City of Portland, Maine - E	Building or Use l	Permit	Application	Permit No:	Issue Date:	CBL:	
389 Congress Street, 04101 Te				10-0628		087 NN	004001
Location of Construction:	Owner Name:		[0	Owner Address:		Phone:	
14 CENTENNIAL ST PEAKS IS	L ZIMMERMAN	N WILL	IAM B & PA	PO BOX 7637			
Business Name:	Contractor Name		(Contractor Address:		i i	3-7650
	Bill Bunton			87 Middle Road C	Cumberland	20777401	1
Lessee/Buyer's Name	Phone:		I	Permit Type:			Zone:
				Single Family			JR-2
Past Use:	Proposed Use:			Permit Fee:	Cost of Work:	CEO District:	
Single Family Home - see permit	Single Family			\$2,595.00	\$250,000.00	1

Framing Observation at Rose Cottage 14 Centennial Street Peaks Island Portland, Maine

MY ROSE COTTAGE

5 EXISTINGNOTTAGE - EAST ELEVATION

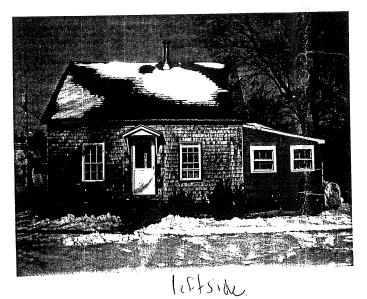
* what happened to enclosed perch

WALL SECTION @ DORMER

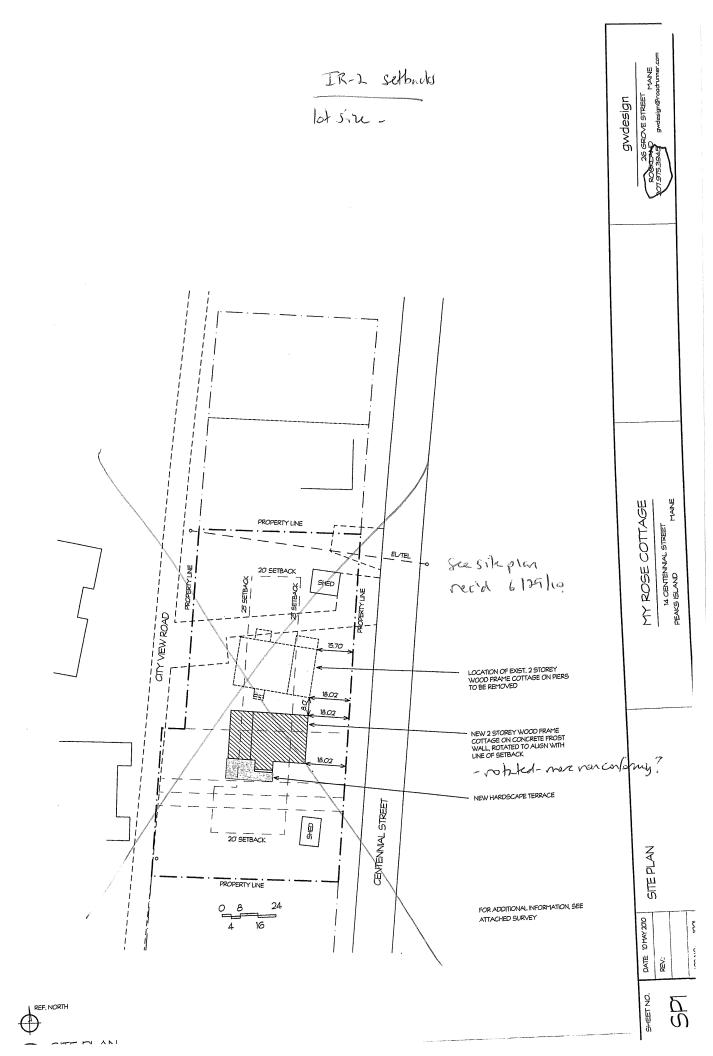
* Week?
